- ATTACHMENT A - SCOPE OF WORK FOR THE CORRECTIVE MEASURES IMPLEMENTATION
- ATTACHMENT B - SCOPE OF WORK FOR A HEALTH AND SAFETY PLAN
- ATTACHMENT C - SCOPE OF WORK FOR AN INTERIM MEASURES PLAN
- ATTACHMENT D - FINAL DECISION AND RESPONSE TO COMMENTS

IN THE MATTER OF:)	FINAL ADMINISTRATIVE
)	ORDER ON CONSENT
American Color & Chemical Corporation)	
)	U.S. EPA Docket No.
Mount Vernon Street)	RCRA-III-082-CA
Lock Haven, Pennsylvania)	
)	
)	
RESPONDENT)	
EPA I.D. No. PAD 00 304 7792)	
)	Proceeding under Section
)	3008(h) of the Resource
)	Conservation and Recovery
)	Act, as amended, 42 U.S.C.
)	Section 6928(h).

FINAL ADMINISTRATIVE ORDER ON CONSENT

FIGURE 3

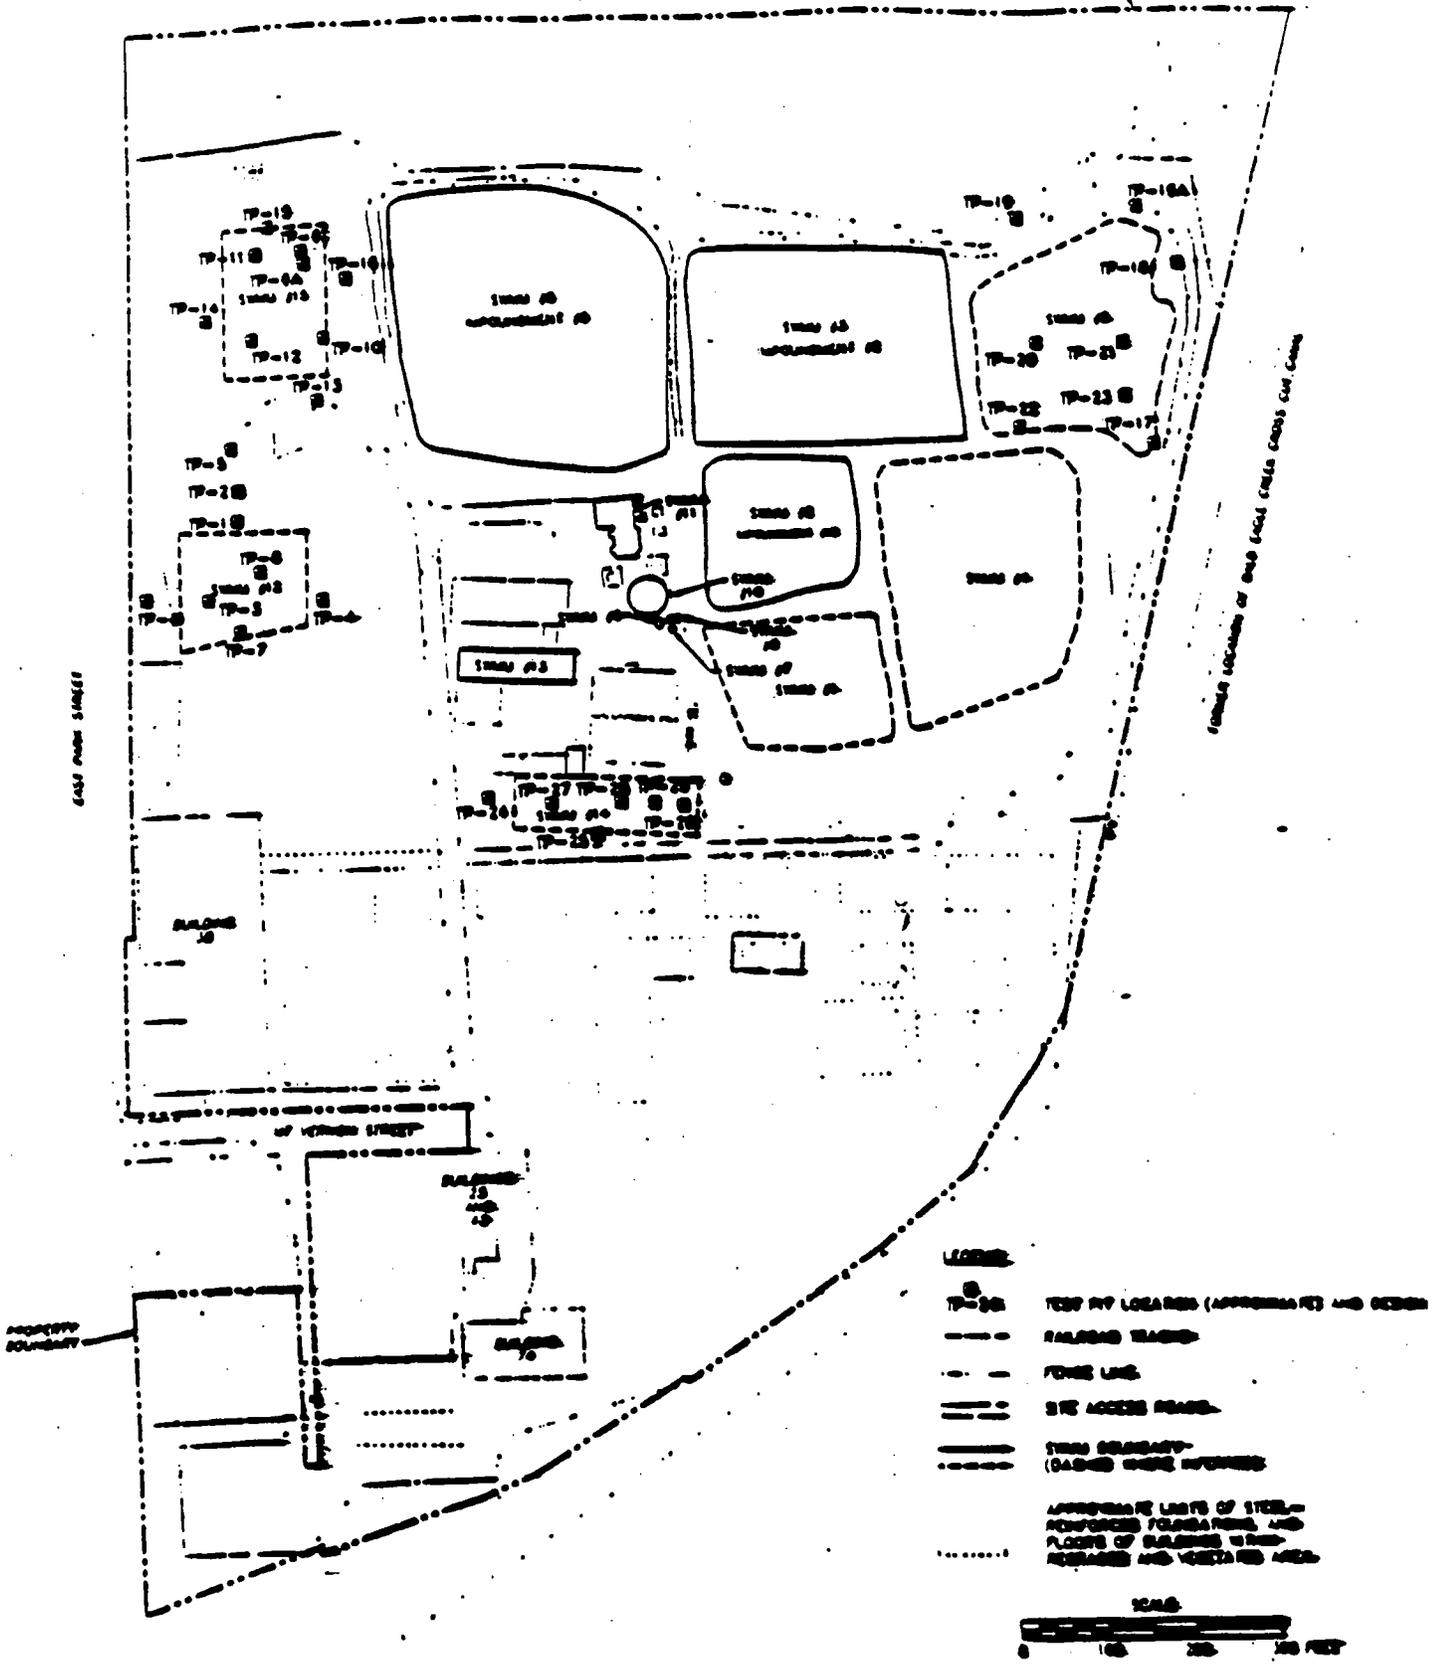
ACCC disputes Figure 3 of the SB, which appears to be a rough, hand-drawn depiction of a plume that appears to be a composite of the ACCC plume and the plume from the adjacent Drake Site. This plume (Figure 3) is terribly misleading and inaccurately depicted. The U.S. EPA-approved RFI supports a differentiation of two plumes; one plume present almost entirely under the ACCC Facility and the second plume that is originating beneath and migrates from the Drake Site towards Bald Eagle Creek. Groundwater analytical data have also indicated that groundwater impacted by the Drake Site has migrated from the Drake Site to the northeast portion of the ACCC Facility. Figure B attached to these comments presents a depiction of the nitrobenzene and phenol plume underlying the ACCC Facility. Figure C attached to these comments presents a depiction of the Drake Site plume containing Fenac and 1,2-dichloroethane (1,2-DCA). Fenac and 1,2-DCA are constituents which were used or produced at the Drake Site and have no history of use or production at the ACCC Facility. These interpretations and depictions were presented in the RFI Report, which was prepared pursuant to the 1991 AOC - between U.S. EPA and ACCC, and which was subsequently approved by U.S. EPA and is now part of the administrative record for the ACCC Facility. ACCC hereby incorporates by reference each document listed in Attachment 1 as further background for this comment.

In the development of the SB, U.S. EPA did not recognize its previously approved differentiation of ACCC Facility and Drake Site plumes, and erroneously depicted one plume, as in Figure 3 of the SB, without any scientific, regulatory, or other basis to do so. It is clear from the RFI as a whole, that the data U.S. EPA used to draw its plume include data on constituents solely originating at the Drake Site, as well as constituents used on both sites. This presentation is terribly misleading. Evaluating data on constituents used primarily by ACCC, it is clear that the ACCC Facility groundwater plume is of limited extent and moves very little on the ACCC Facility, as is depicted in Figure B.

EPA's Response: EPA did not indicate that the contaminant plume shown in Figure 3 of the SB is solely from the ACCC Facility. EPA indicated that the Figure is a general depiction of the areas that have been affected by groundwater contamination but does not specifically show where certain contaminants are located. Also, EPA indicated that the plume in Figure 3 was drawn using a combination of contaminant plumes (1,2 dichlorobenzene, chlorobenzene, nitrobenzene, 1,2 dichlorobenzene, fenac, phenol and toluene) which are individually shown in greater detail in the EPA-approved RFI, Figures RFI-D24 through RFI-D30. There are also contaminants which were used at both ACCC and Drake. These contaminants are: 1) 1,2 dichlorobenzene, which was included in the RFI as Figure RFI-D24 and provided in this document (Attachment 3), appears to be solely on ACCC property with some contaminant on the northern tip of the Drake facility; 2) Chlorobenzene, which was included in the RFI as Figure RFI-D25 and provide in this document (Attachment 3), appears to be on both the ACCC property and Drake; and 3) Toluene, which was included in the RFI as Figure RFI-D30 and provided in this document (Attachment 3), appears to be solely on ACCC property with some contaminant on the northern tip of the Drake facility. Furthermore, ACCC's comments suggest that ACCC is not responsible for these contaminants. However, ACCC's statement that the ACCC plume is clearly of limited extent and moves very little on the ACCC property does not take into consideration the contaminant plume shown on RFI-D24, RFI-D25 and RFI-D30 in the EPA-approved RFI. Indeed, were one to use the same argument for the contaminants 1,2 dichlorobenzene, Chlorobenzene and Toluene, as ACCC used for Fenac and 1,2 dichloroethane, one could conclude

that these constituents originated from ACCC and contaminated the groundwater beneath Drake. EPA has always believed that both ACCC and Drake are responsible for the contaminated groundwater plume shown in Figure 3 of the SB.
